CCK-2568-22

ADDENDUM # 4

CONSTRUCT/ IMPROVE GREEK HOUSING (DELTA GAMMA) Bid Package #2 – All Work Categories

UNIVERSITY OF KENTUCKY
 2555.0 Construct/Improve Greek Housing
 (Delta Gamma House)

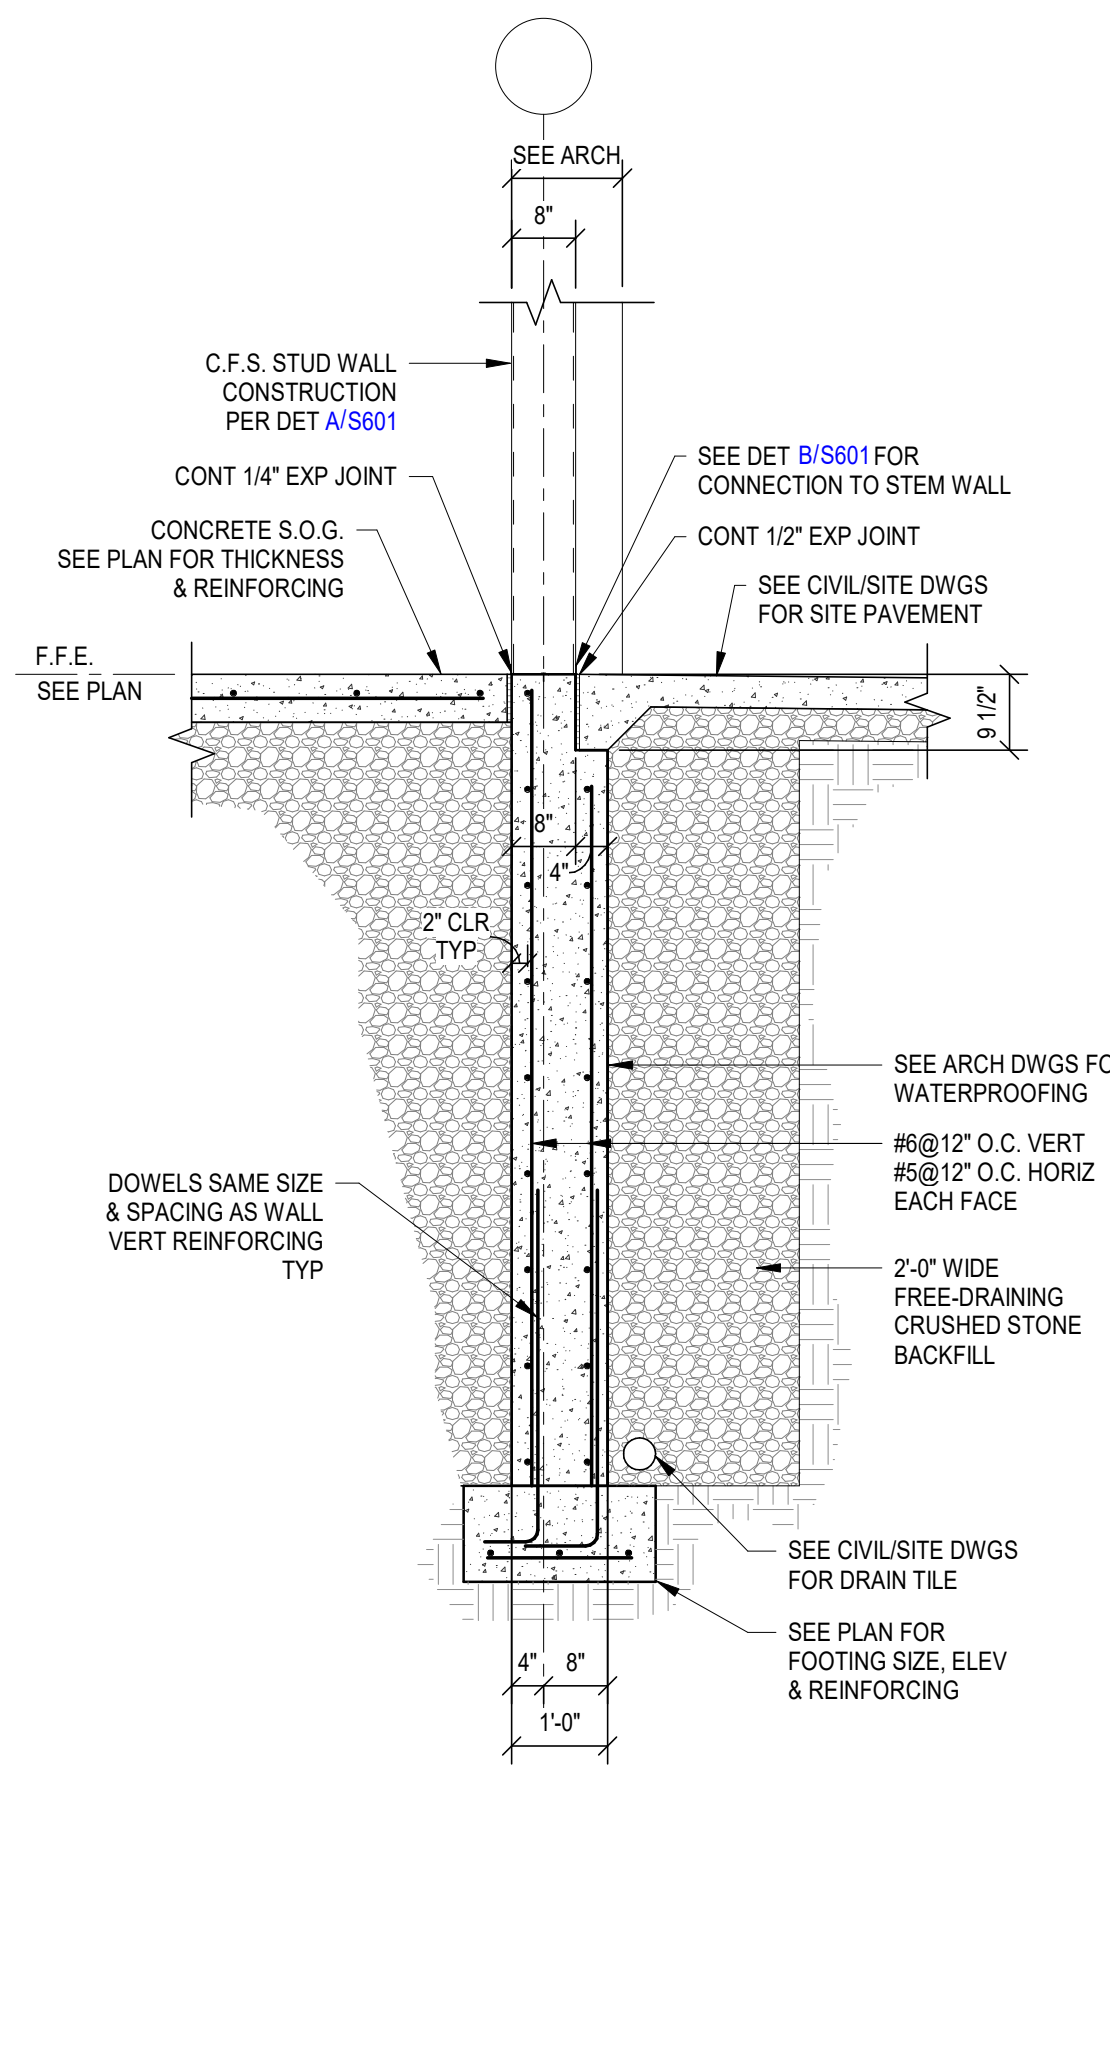
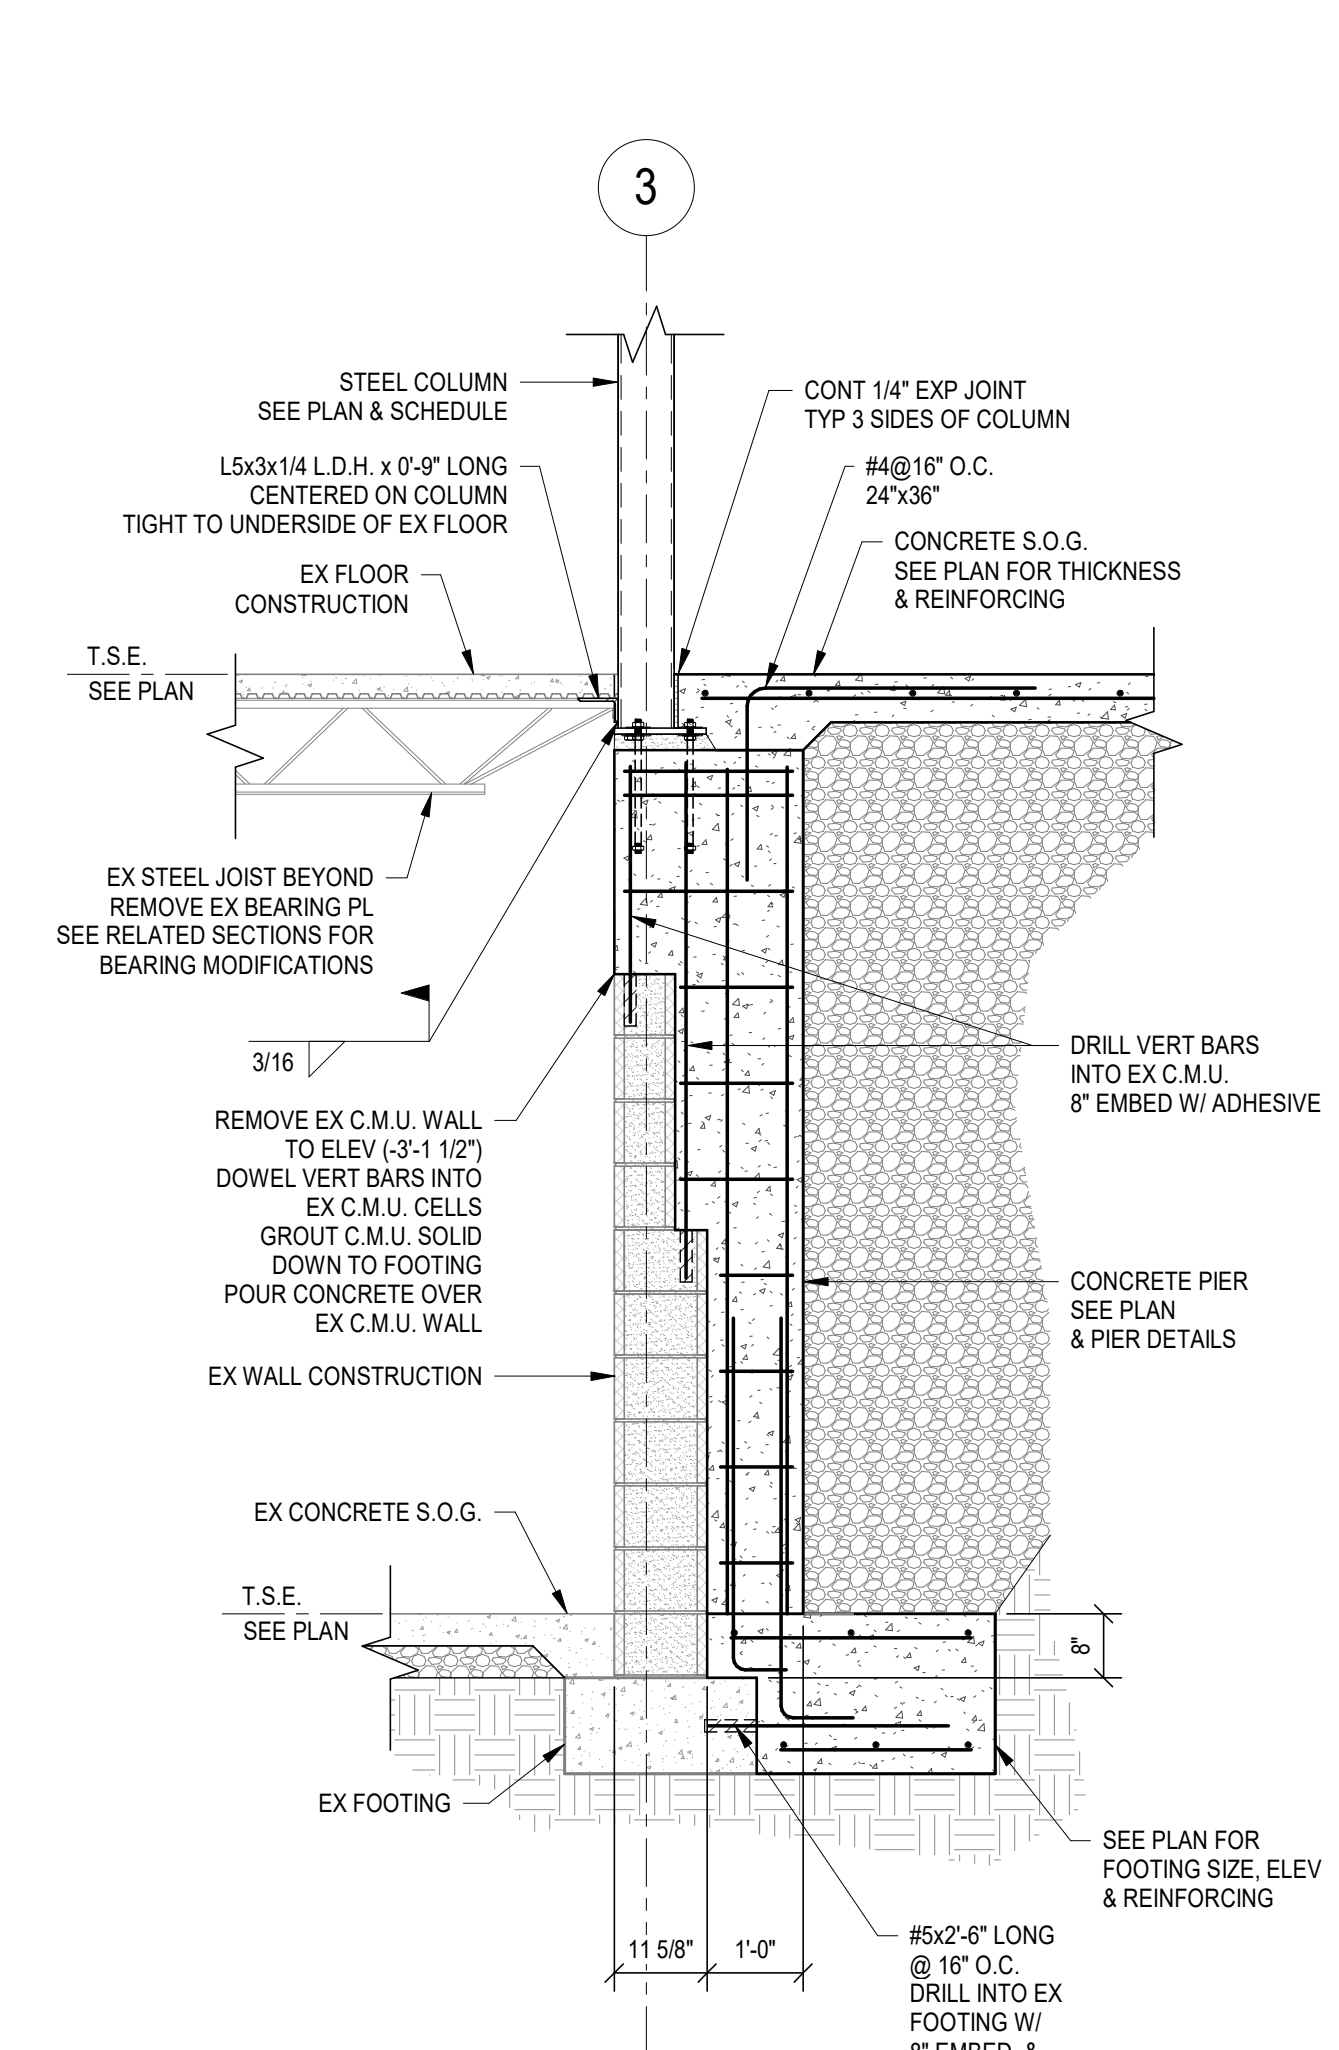
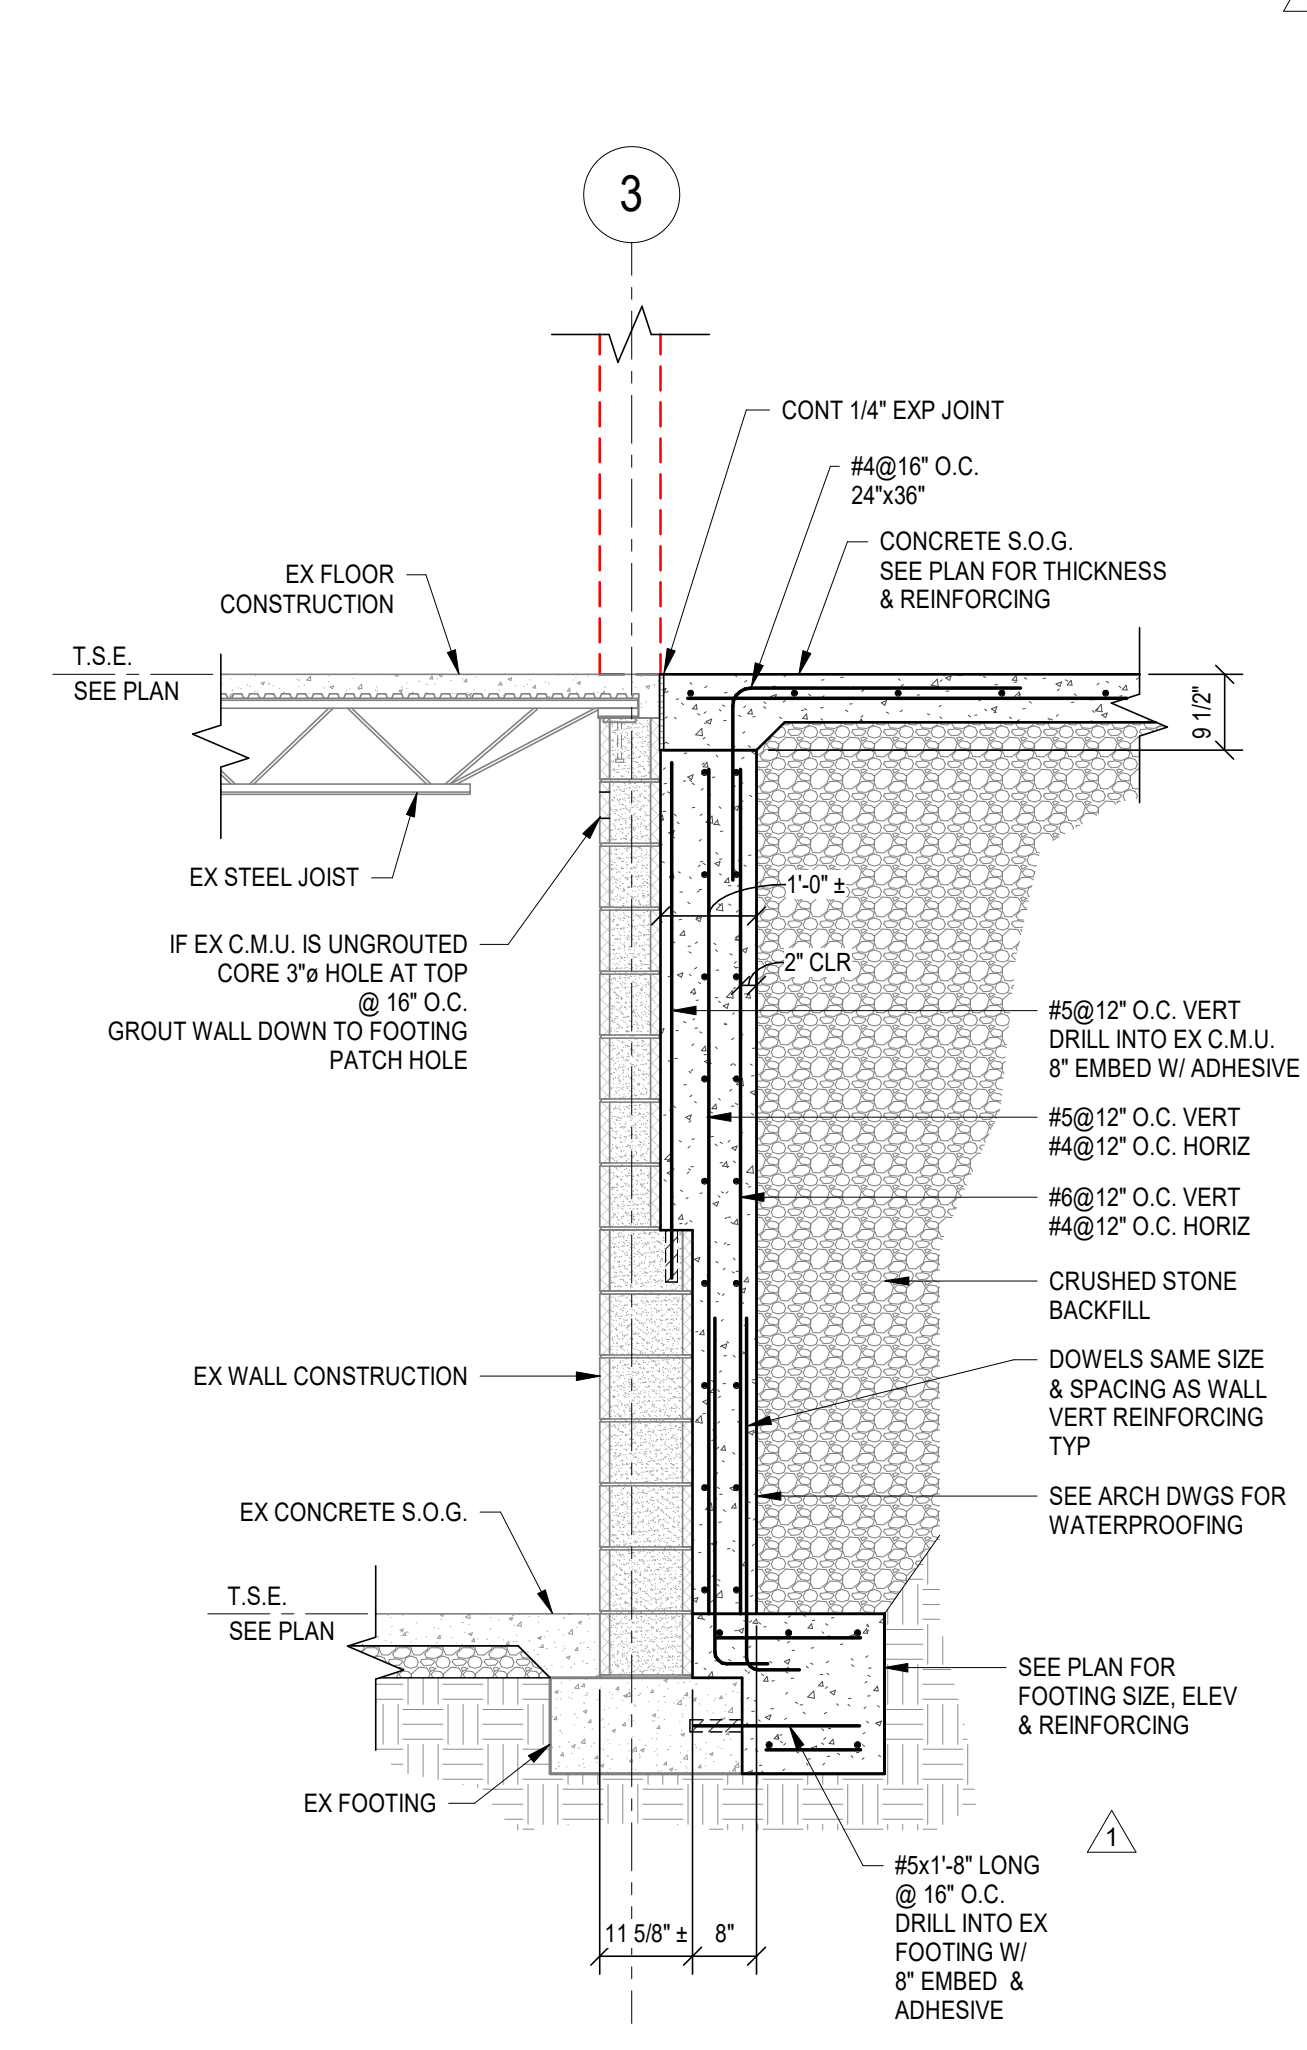
<ul style="list-style-type: none"> • Changed Tag Note 31 to "NEW JOIST BEARING PER DET L/S402 OR DET J/S404." 	
S305	FOUNDATION SECTIONS	9/7/21
	<ul style="list-style-type: none"> • Section C/S305 – Edit foundation dowel note. • Added Section D/S305. 	
S402	TYPICAL FRAMING DETAILS	9/7/21
	<ul style="list-style-type: none"> • Added Detail L/S402
